STATE HIGHWAY 105 / JACKSON CREEK PKWY. - PHASE 2 CONSTRUCTION PLANS			
ROADWAY IMPROVEMENT PLANS			
STANDARD NOTES			
DESIGNED BY	PRA	SCALE	DATE 02-23-23
DRAWN BY	PRA	(H) 1"=VARIES	SHEET 2 OF 23
CHECKED BY	(V) 1"= N/A	JOB NO.	1.302.22

STATE HIGHWAY 105 / JACKSON CREEK PKWY. - PHASE 2 CONSTRUCTION PLANS			
ROADWAY IMPROVEMENT PLANS			
DEMOLITION PLAN			
DESIGNED BY	PRA	SCALE	DATE 02-23-23
DRAWN BY	PRA	(H) 1" = 60'	SHEET 4 OF 23
CHECKED BY	(V) 1" = N/A	JOB NO.	1302.22

STATE HIGHWAY 105 / JACKSON CREEK PKWY. - PHASE 2 CONSTRUCTION PLANS  
 ROADWAY IMPROVEMENT PLANS  
 JACKSON CREEK PKWY. ROADWAY SECTIONS

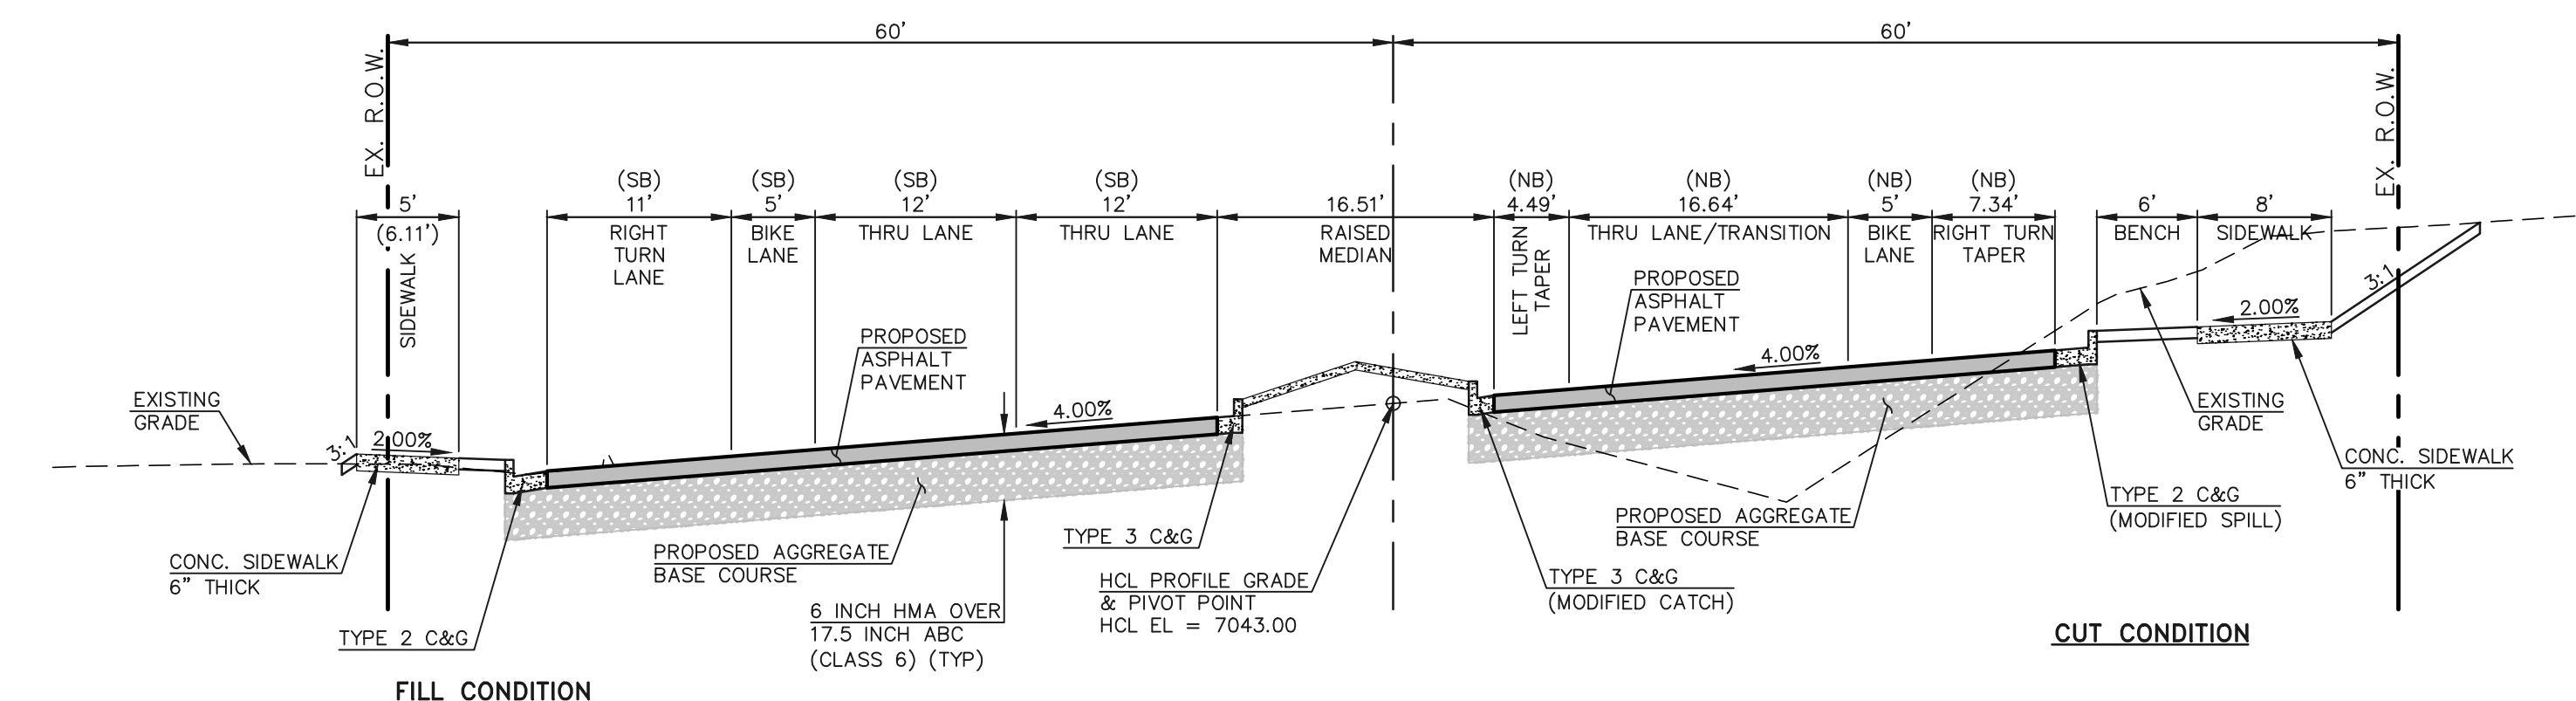
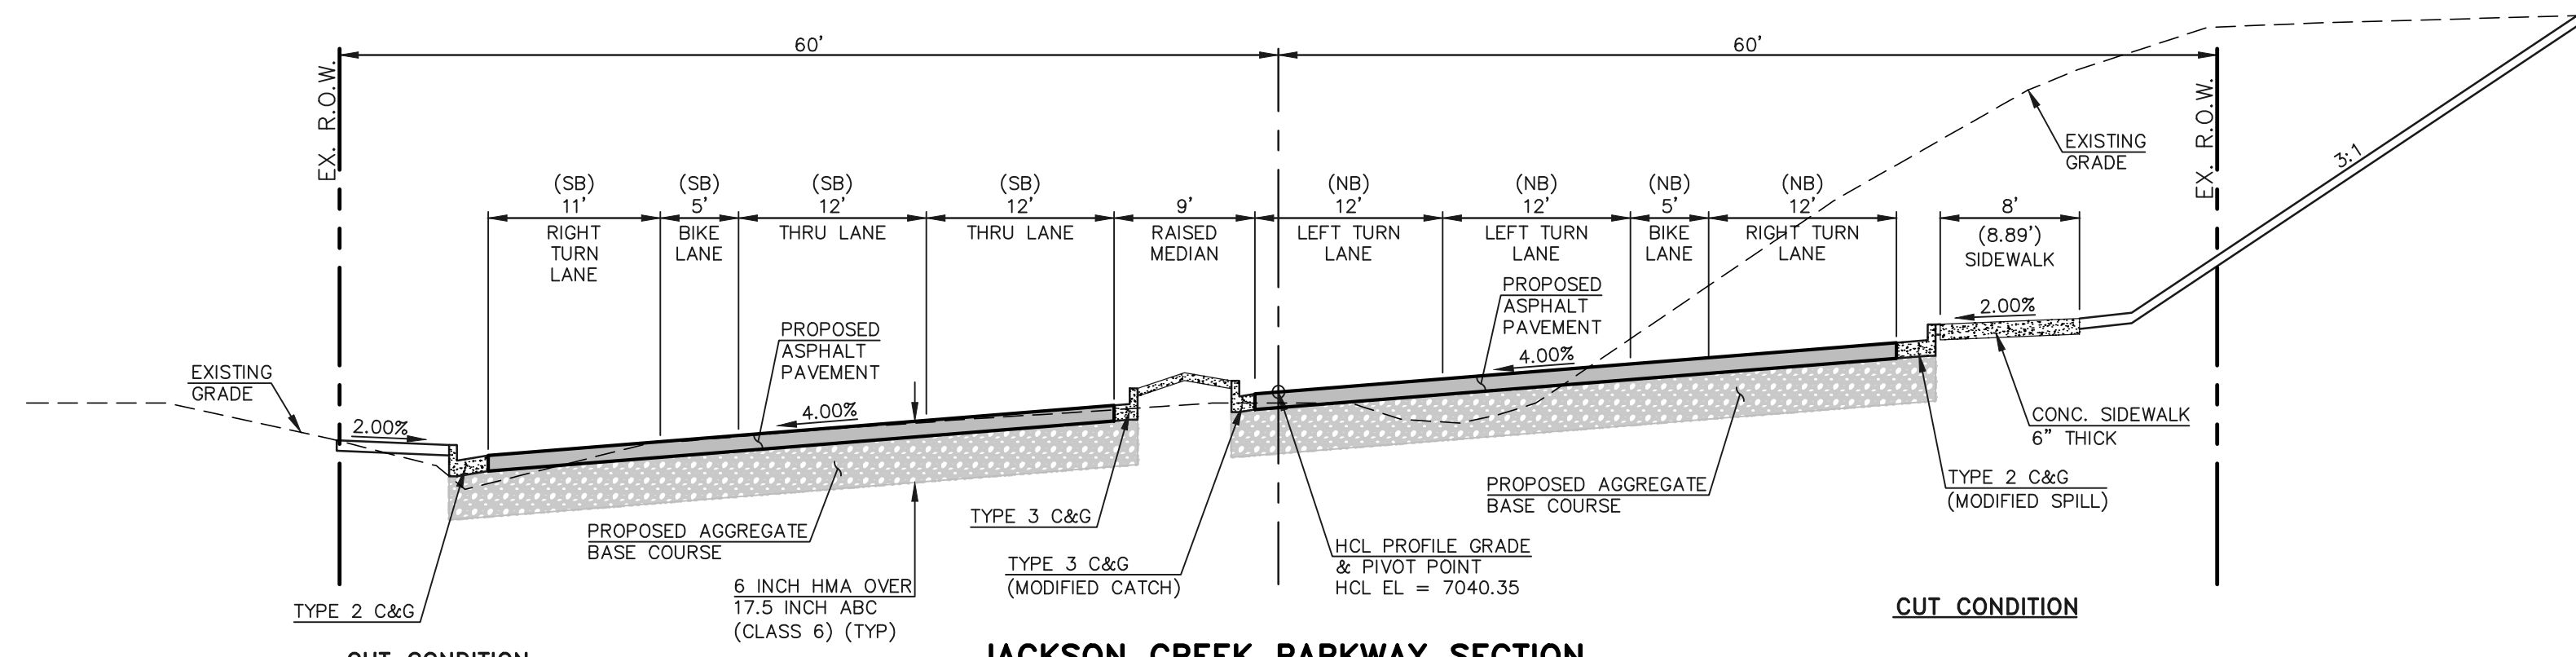
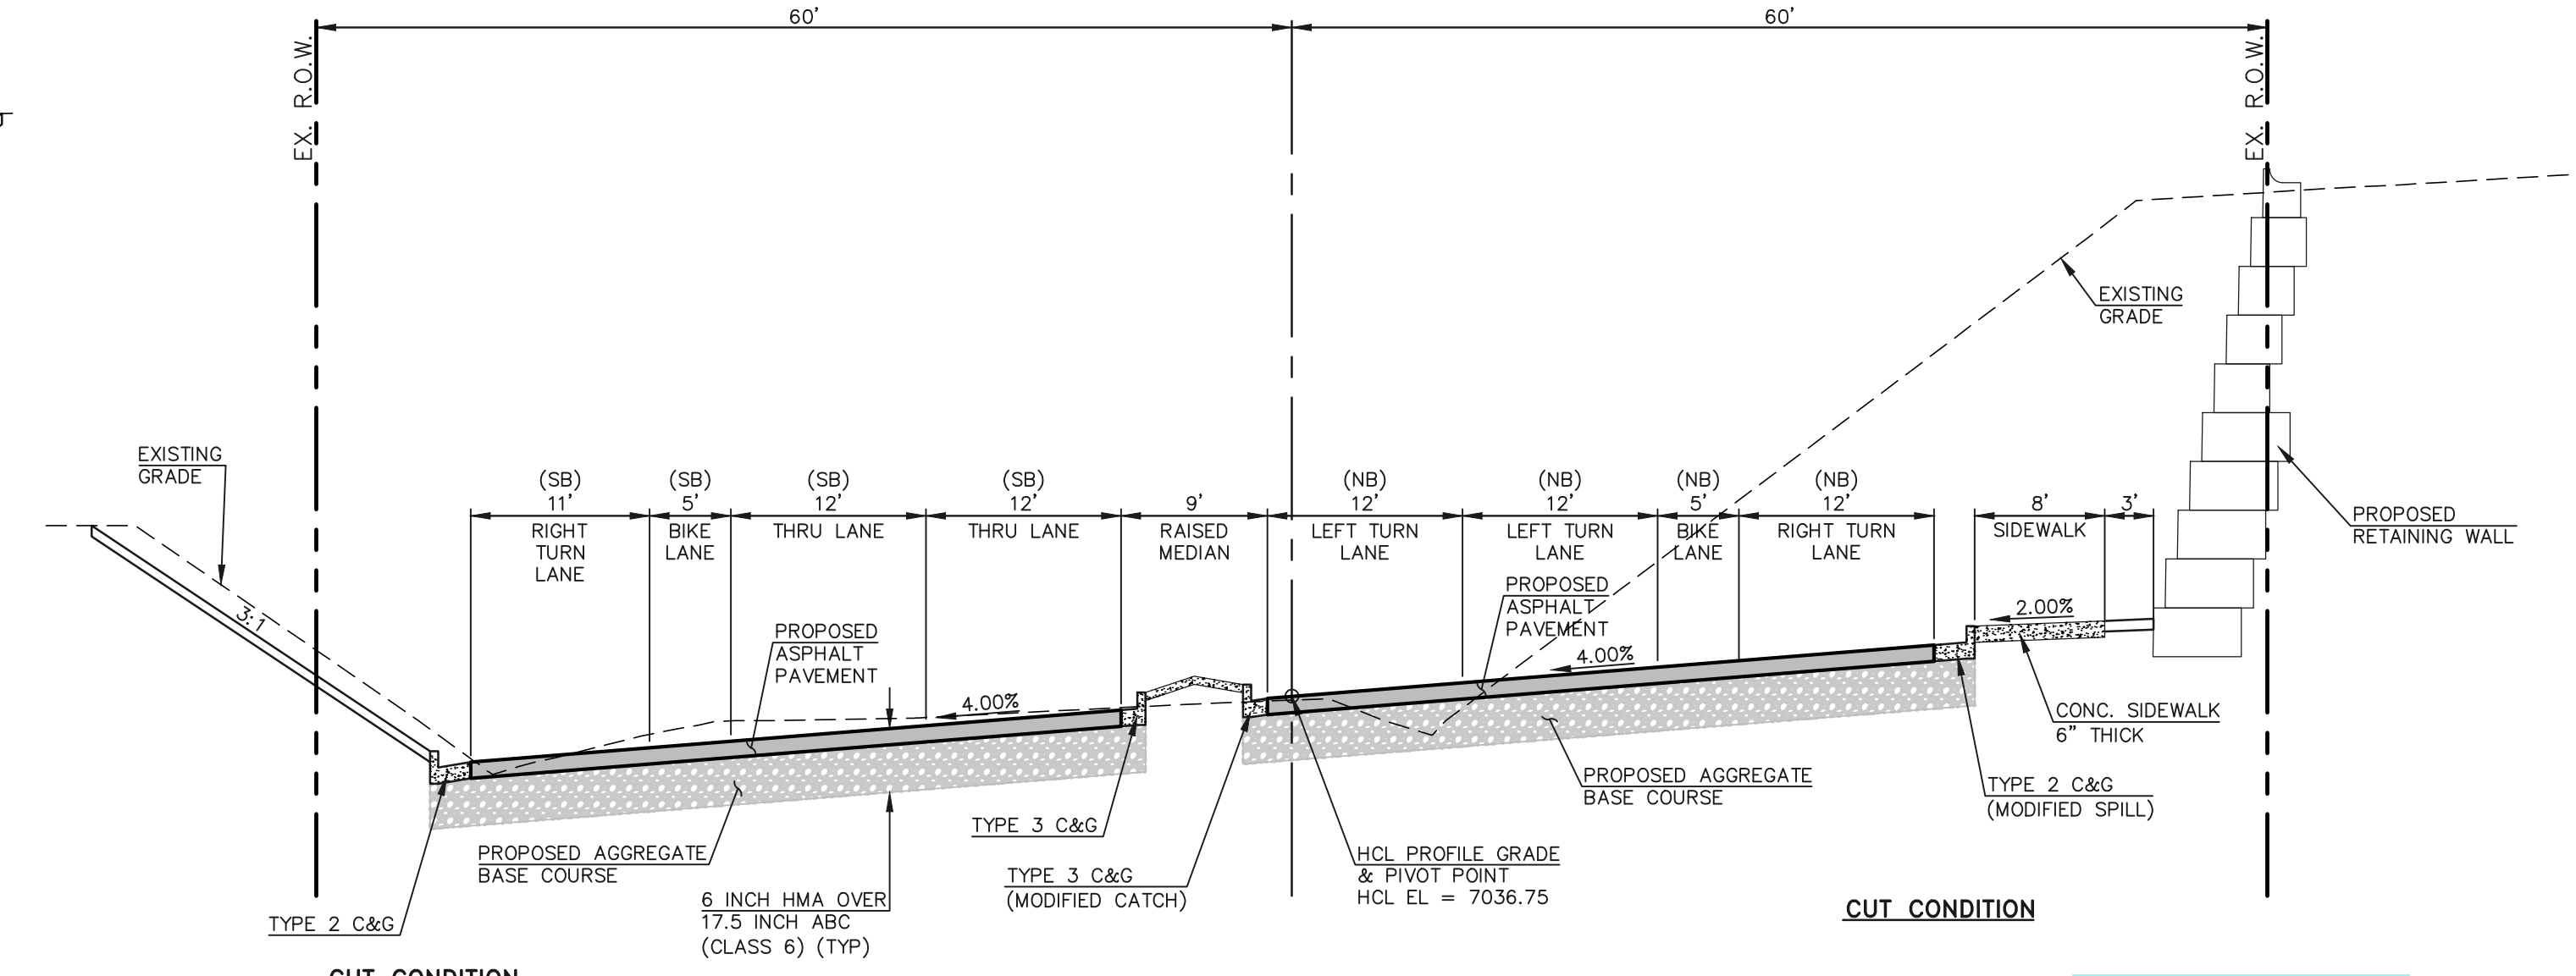
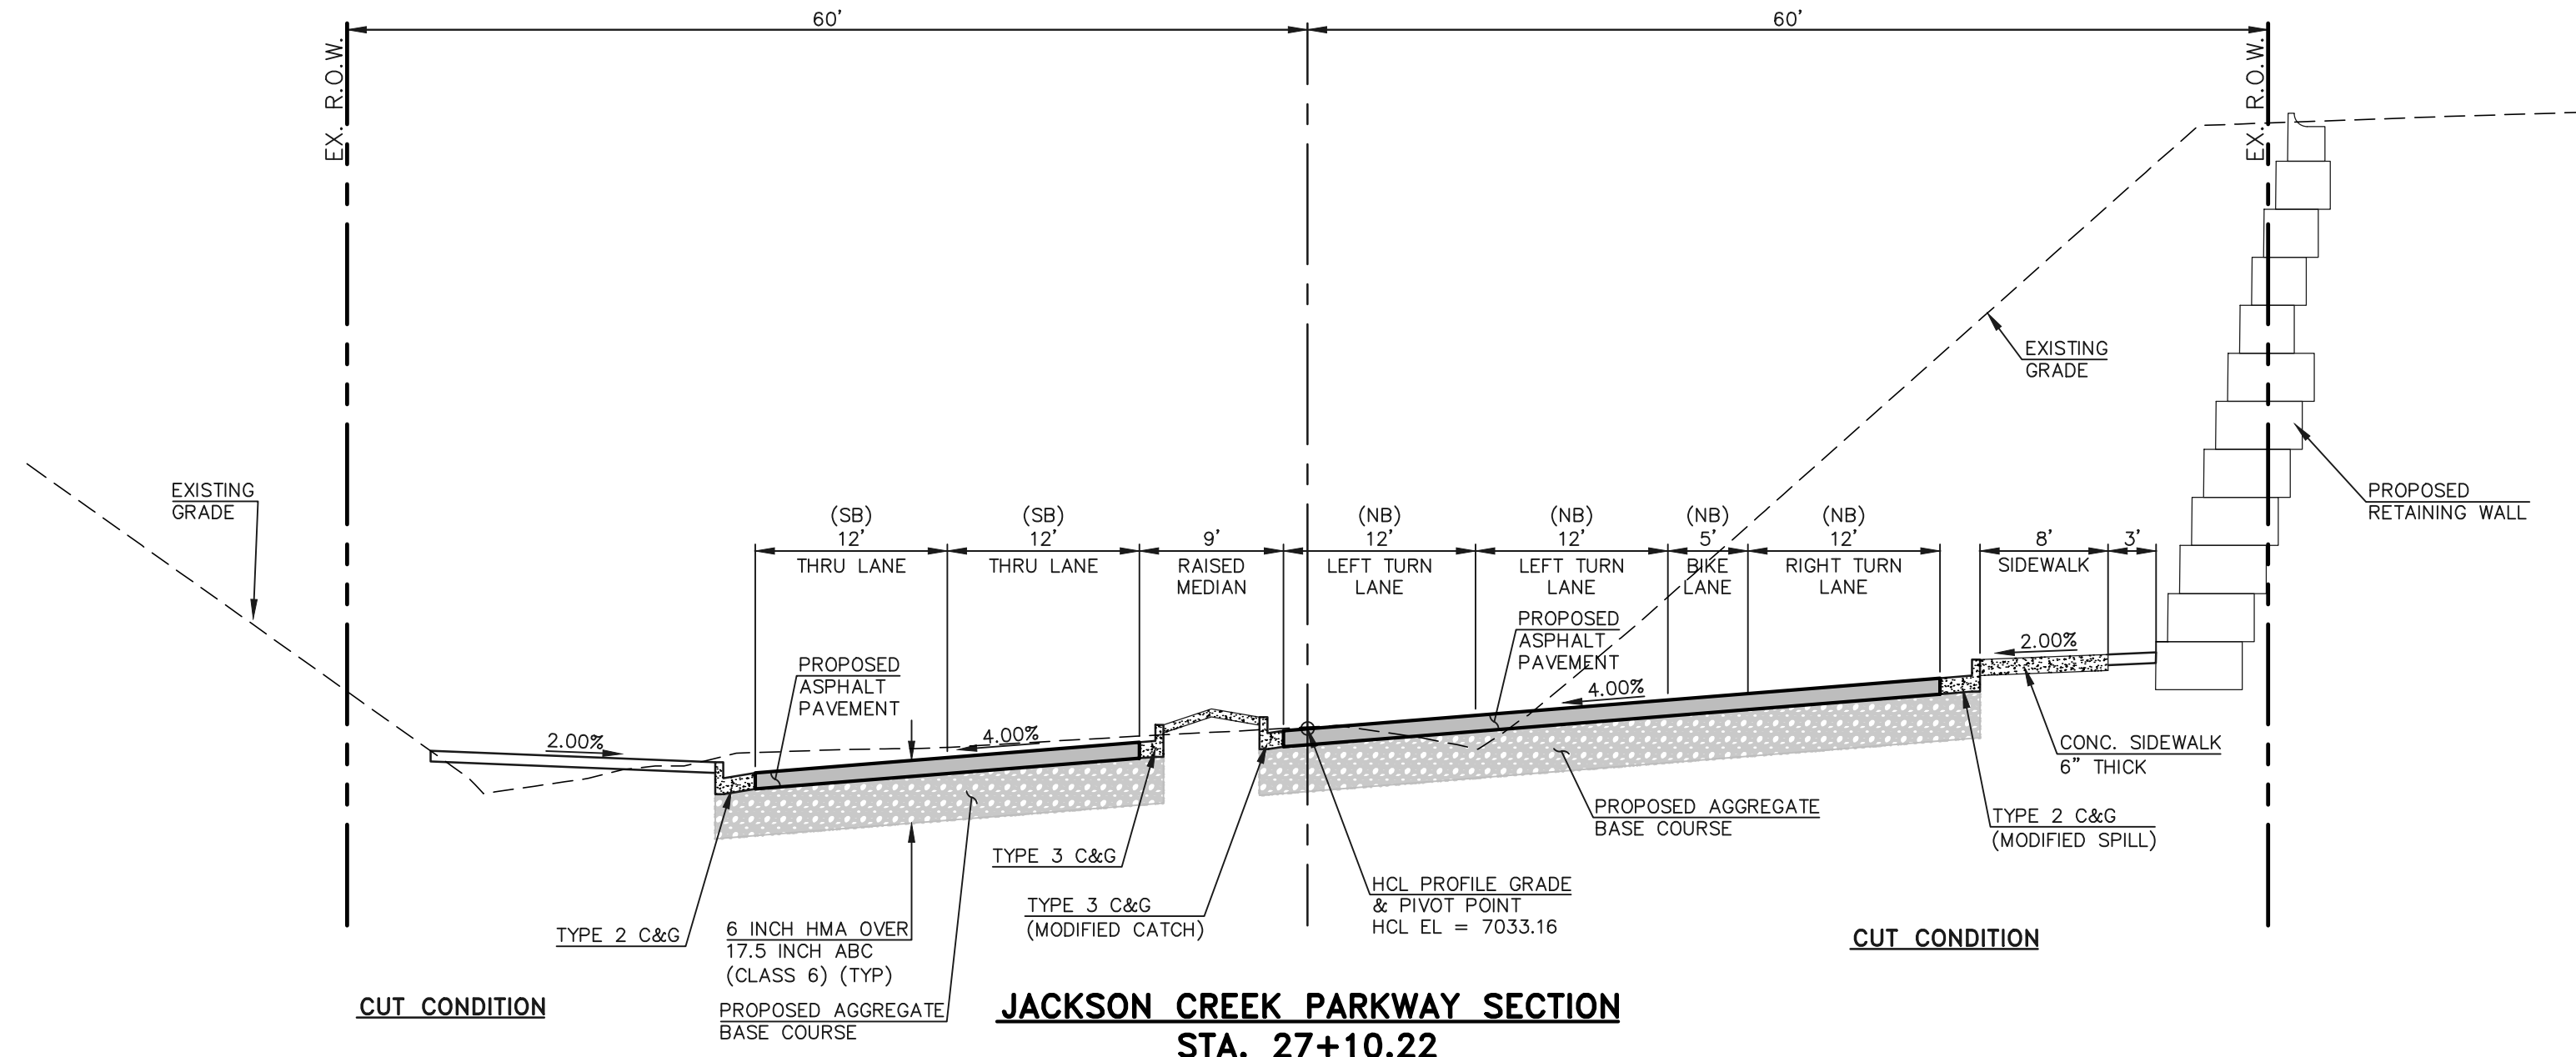
PROVIDE SECTION FOR HWY 105 (EPC). SHOW MILL & OVERLAY DEPTHS ON SECTION. ALSO SHOW ASPHALT AND BASE DEPTHS - SHOULD MATCH HWY 105 DESIGN DEPTHS FOR WIDENED AREA
